MONTGOMERY COUNTY HISTORIC PRESERVATION COMMISSION
STAFF REPORT

Address:	5912 Cedar Parkway., Chevy Chase	Meeting Date:	8/16/2017
Resource:	Contributing Resource Chevy Chase Village Historic District	Report Date:	8/9/2017
Applicant:	Blake and Sydney Bath (Adele O'Dowd, Agent)	Public Notice:	8/2/2017
Review:	HAWP	Tax Credit:	N/A
Case Number:	35/13-17BB	Staff:	Michael Kyne
PROPOSAL:	Hardscape and landscape alterations

PROPOSAL:

LANDSCAPE
LAYOUT
PLAN

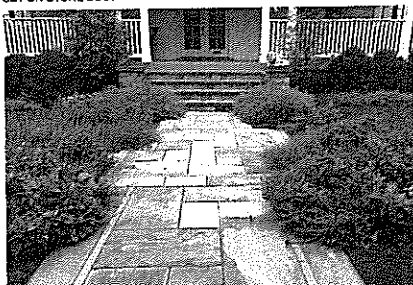
FRONT WALK
PA BLUESTONE, NATURAL VARIATION IN COLOR, NATURAL CLEFT
1" WIDE PA BLUESTONE BORDER, LIKE 7 HESKETH
SET ON STONE DUST

DRIVEWAY
BELGIAN BLOCK TRANSITION TO DELAWARE RIVER GRAVEL 1/4"
BELGIAN BLOCK EDGING SET FLUSH
13' WIDE AT STREET TO MAINTAIN EXISTING WIDTH, 15' WIDE MAXIMUM AT GARAGE

STONE VENEER TO REPAIR EXISTING WALL TO MATCH NEIGHBOR, BELOW

Existing Property Condition Photographs (duplicate as needed)

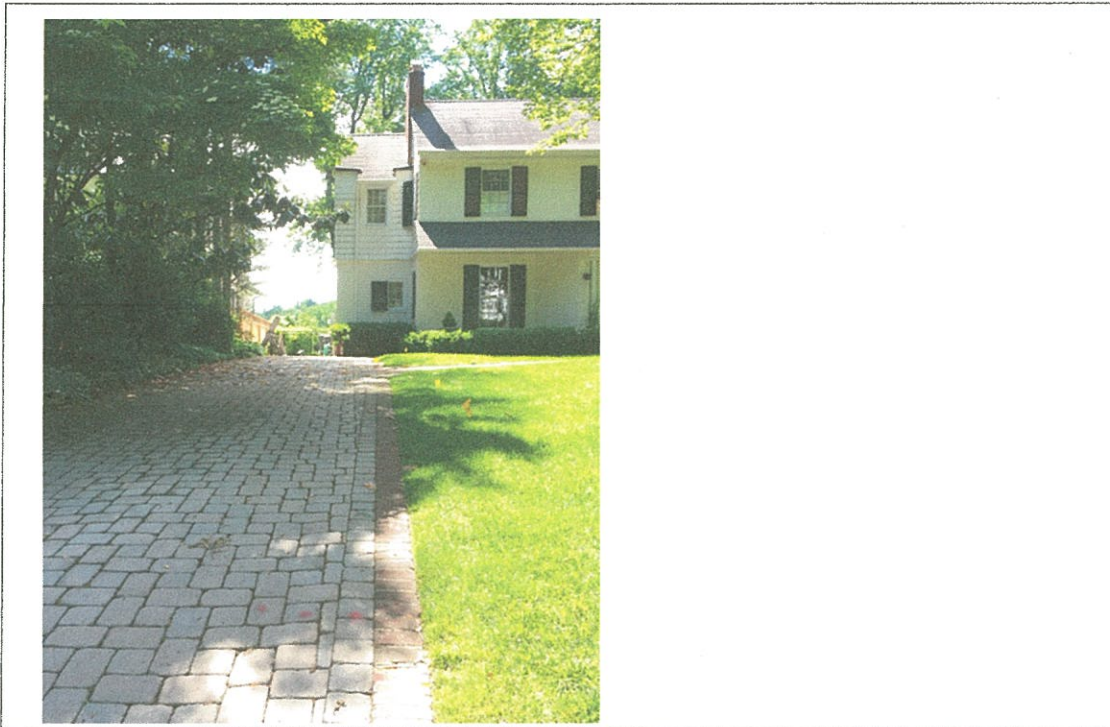
Detail: IMPERVIOUS FRONT WALK SET IN CONCRETE TO BE REPLACED WITH PA BLUESTONE
SET ON DUST

Detail: BRICK STEPS TO BE REBUILT IN LINE WITH STRAIGHT BLUESTONE FRONT WALK

Existing Property Condition Photographs (duplicate as needed)

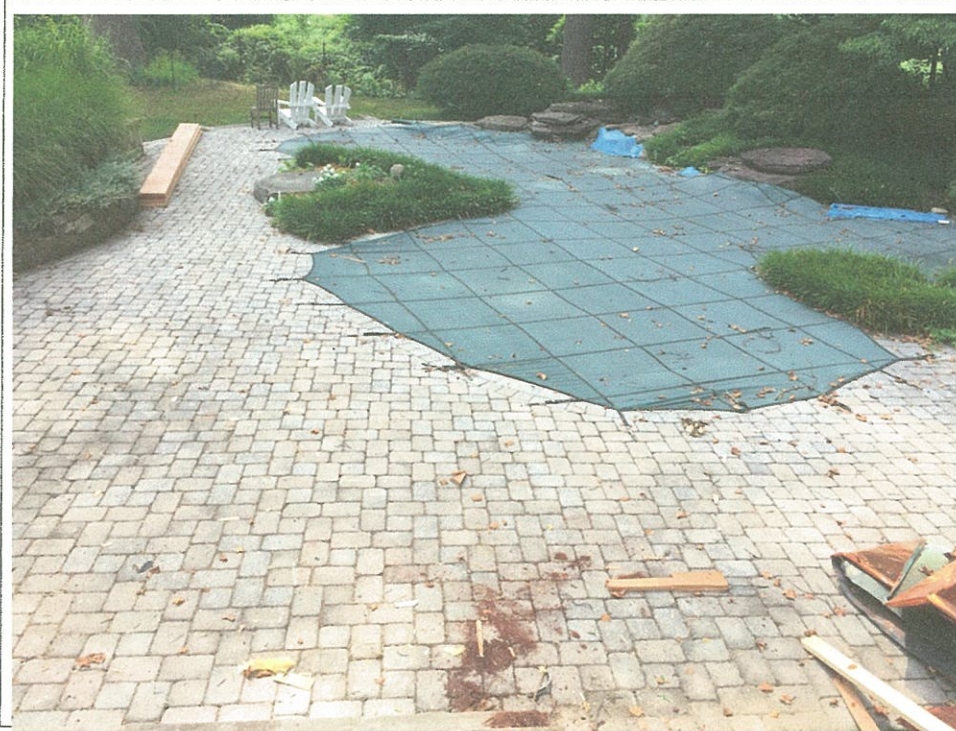
Detail: CONCRETE PAD PREVIOUSLY APPROVED FOR REMOVAL :
HPC CASE NO. 35/13-17B AND IT WAS APPROVED AT THE 1/25/17 HPC MEETING

EXISTING IMPERVIOUS PAVER DRIVEWAY TO BE REMOVED AND REPLACED WITH SECTIONS OF
Detail: COBBLE AND PERMEABLE GRAVEL, HISTORICALLY APPROPRIATE
